INTERA/RAML

Responses to Comments

Ambrosia Lake Work Plans 2017 and 2018

Figure 7: Depth to water at 5-73 ALL and 5-73 ALL-R, which replaced the original well in 2013.

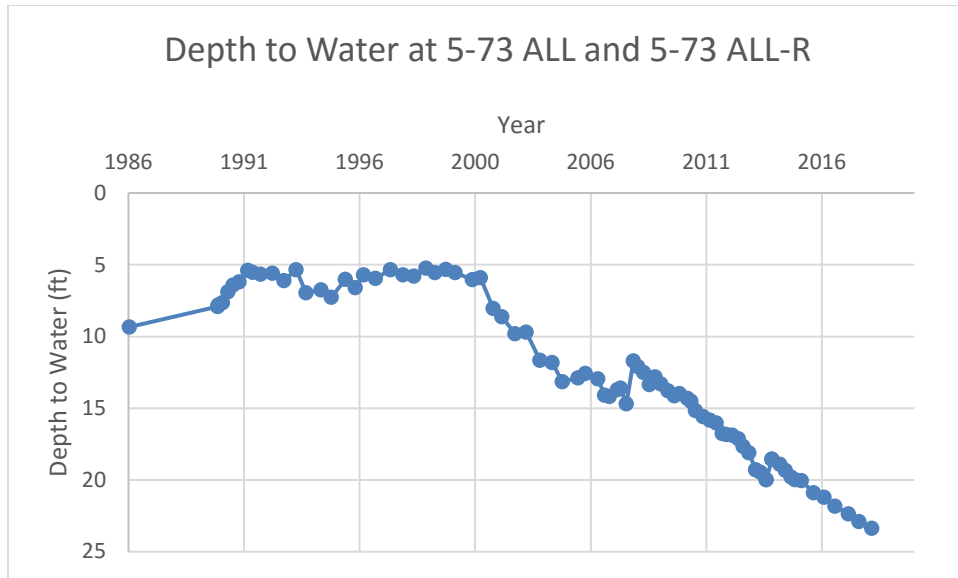
Comment 7: *Is there information on the seasonality of water levels, which may also influence contaminant concentrations, in the alluvial sediments along the Arroyo del Puerto?*

Groundwater elevations in alluvial well 5-73 ALL (and its replacement, 5-73 ALL-R) (**Figure 7** [below]) and TRB well 31-02 TRB (and its replacement 31-02 TRB-R) (**Figure 8** [below]) are plotted over time below.

Figure 1
Dakota Potentiometric
Surface Contours
Rio Algom Mining LLC,
2017 ACL Workplan: Response to Comments

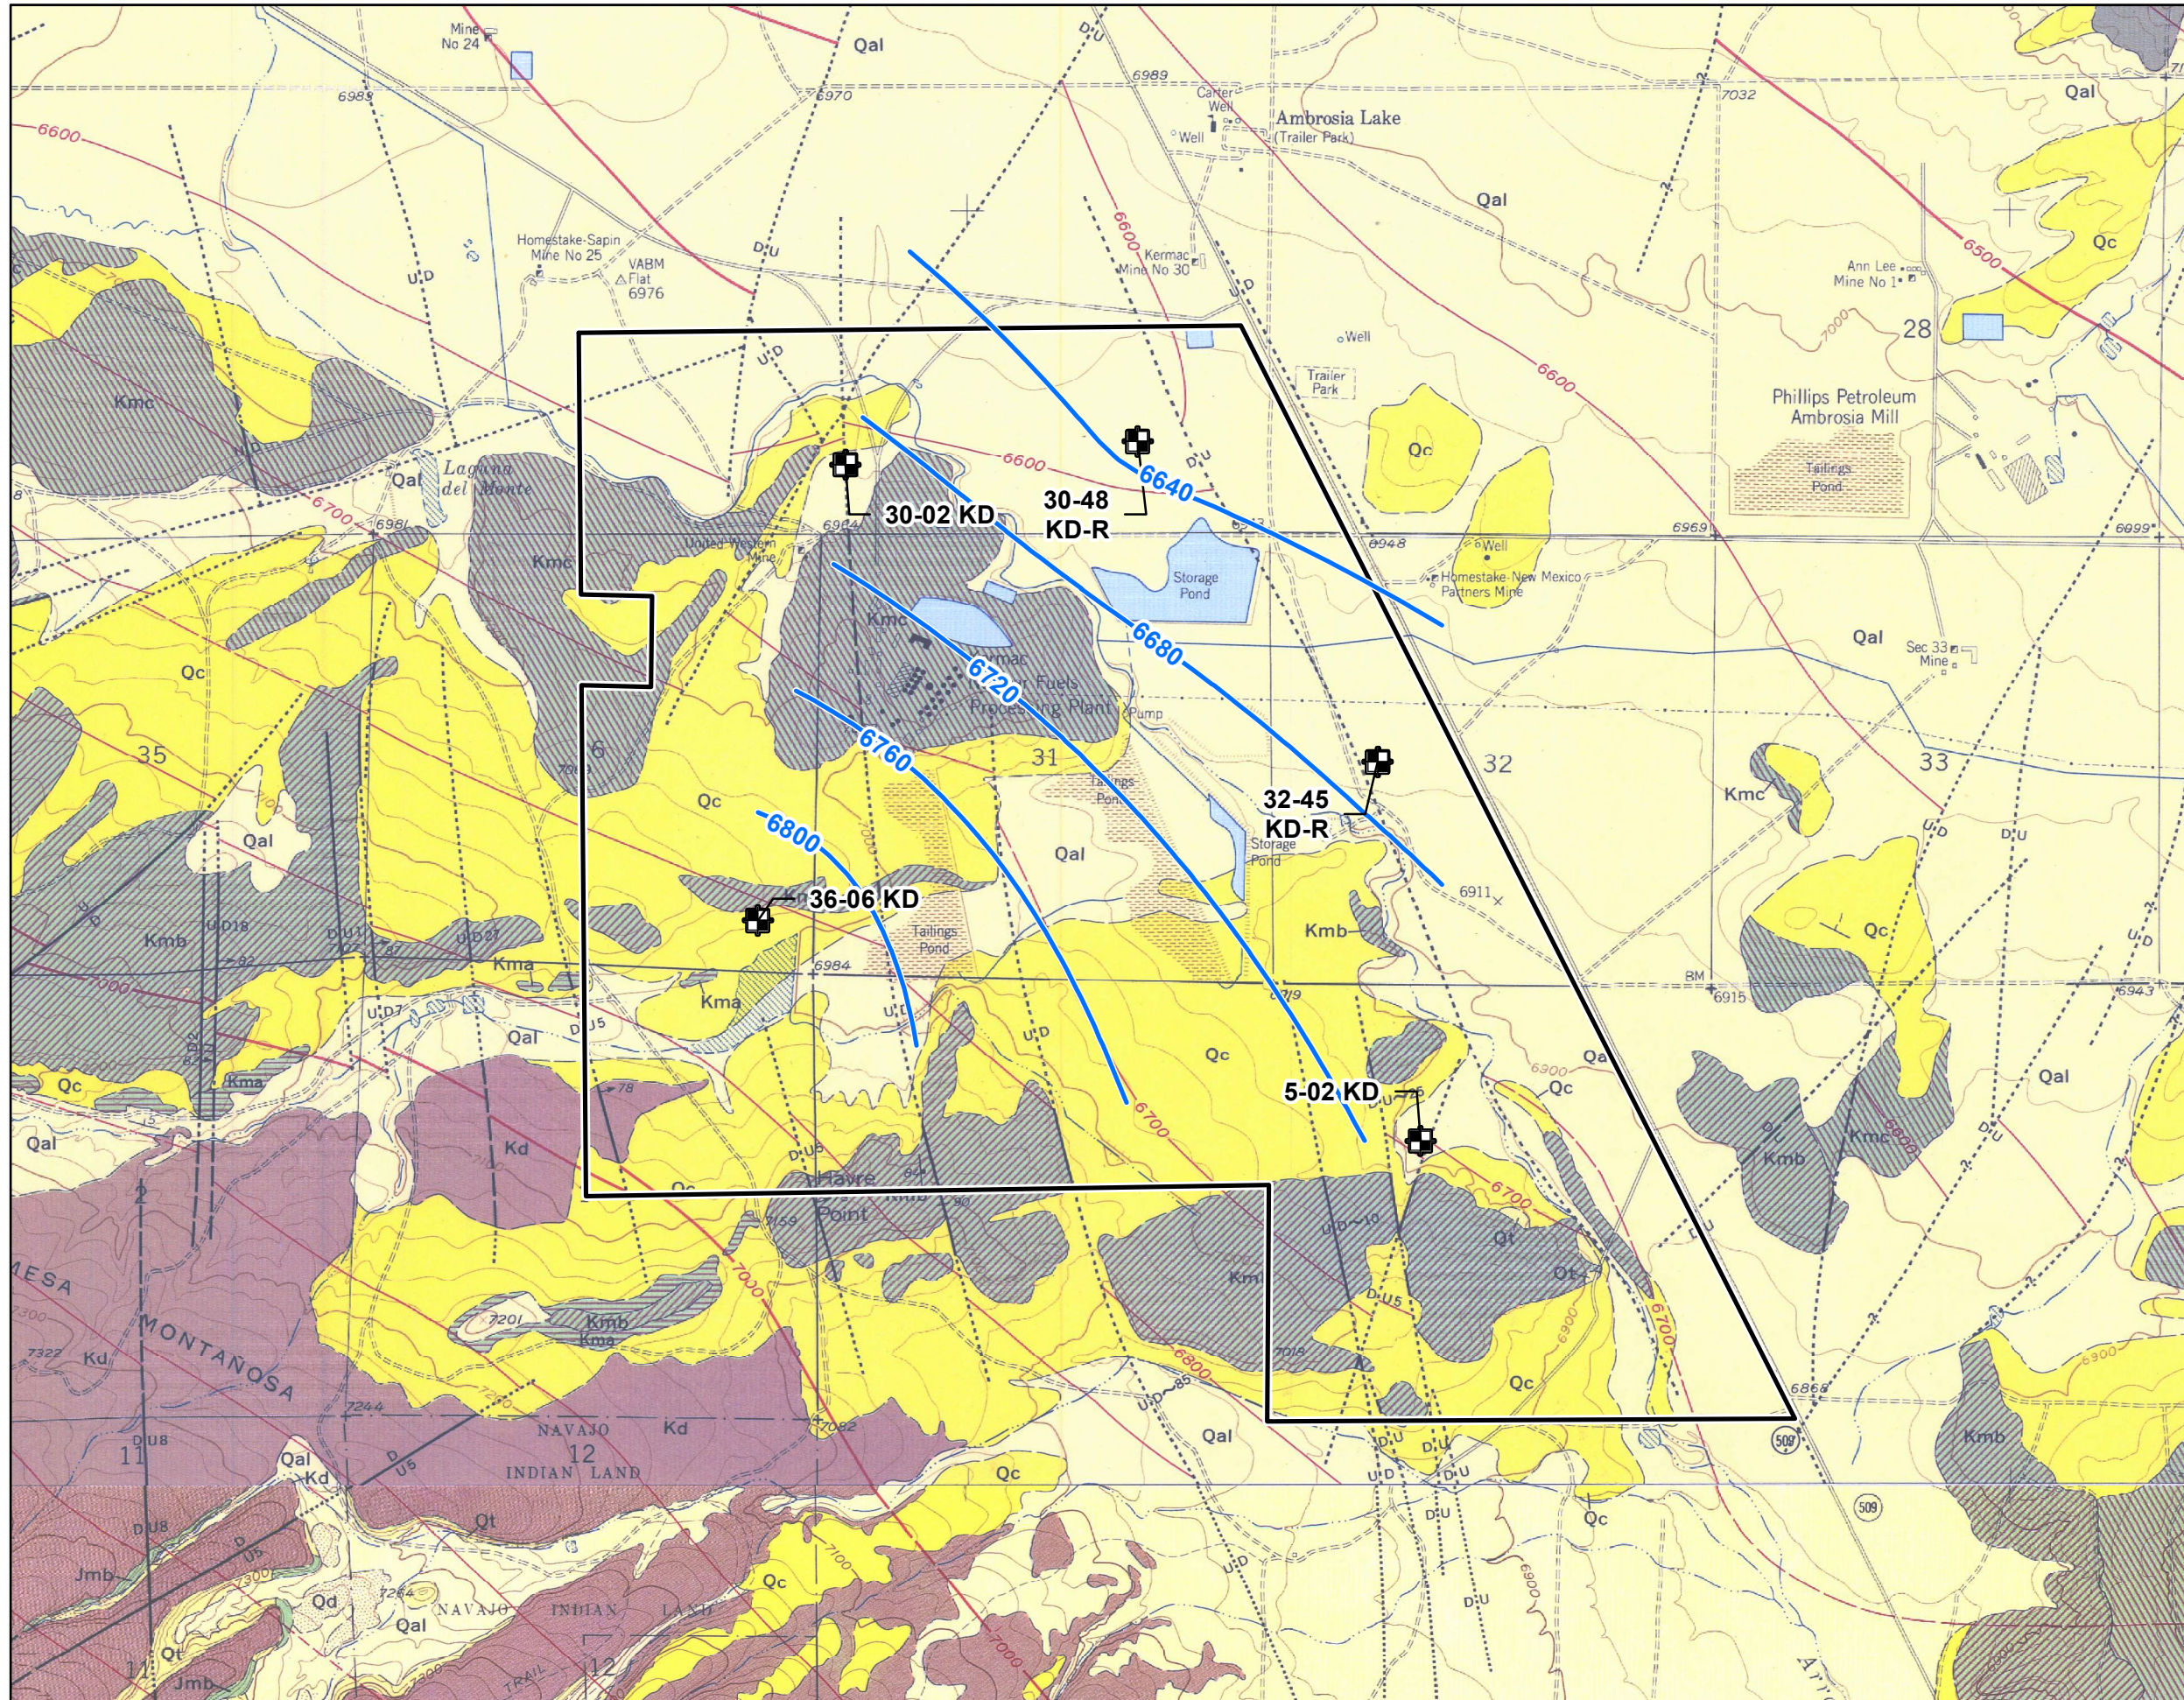
Comment 3: *What are the roles of faults and paleotopography in transport pathways? Would leakage through faults change the monitoring strategy? Would transport pathways along faults or paleochannels change the monitoring strategy?*

The bedrock ACL document (Quivira, 2000) reports: “Most of the faults are normal dip-slip faults with less than 40 feet of displacement.” One fault near the LTSM area has an offset of 85 feet

(**Figures 1 and 2** [attached]; Santos and Thaden, 1966). Offsets of other faults near the LTSM area range from 2 feet to 25 feet (**Figures 1 and 2** [attached]; Santos and Thaden, 1966). Offset is not indicated for many of the faults. Also evident from the USGS map is the limited extent of the faults in the area. It is unclear whether the limited extent of a fault was supported by data or whether data was not available with which to continue mapping the fault. If a fault is of limited extent, its influence on groundwater flow would likewise be expected to be limited.
